Buckhorn Mountain Mine, Washington

Independent Monitoring Goal

- Provide input about the adequacy of the hydrogeologic and water quality monitoring of the mine and associated mitigations
- Suggest modifications to monitoring and adaptive management plans that will help ensure protection of the environment

Figure 1. Comparison of Measured and Predicted Flows at SW-4, Lower Gold Creek: 2005-2008

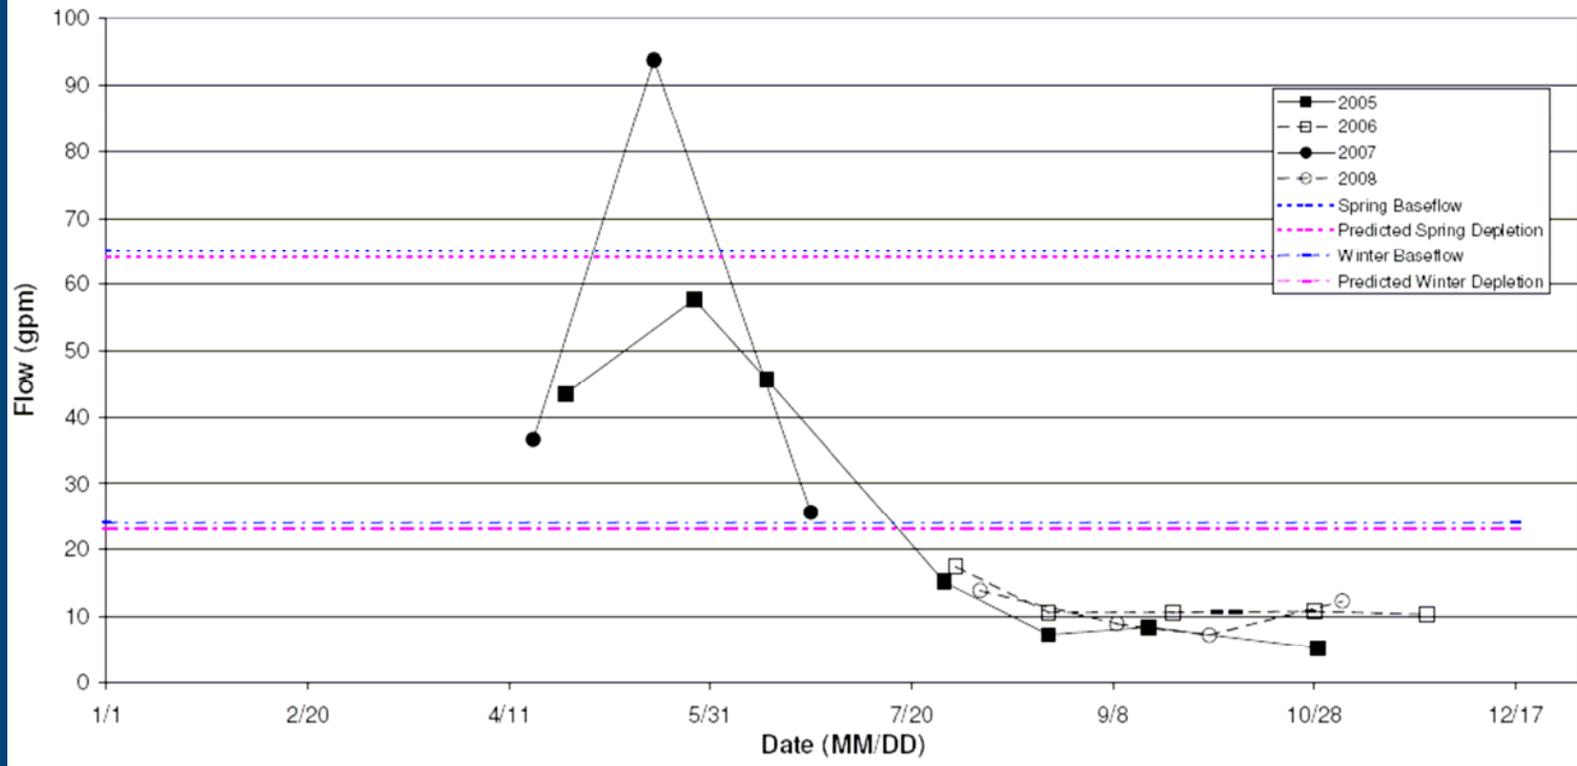
Measured vs. Predicted Flow Issues

- Measured low flows (fall/winter) are often substantially lower than modeled baseflows
- FEFLOW model does not adequately simulate pre-mining conditions
- Need precipitation data from the mine and historic streamflows as input to model

Modeled low flows are substantially larger than the measured flows
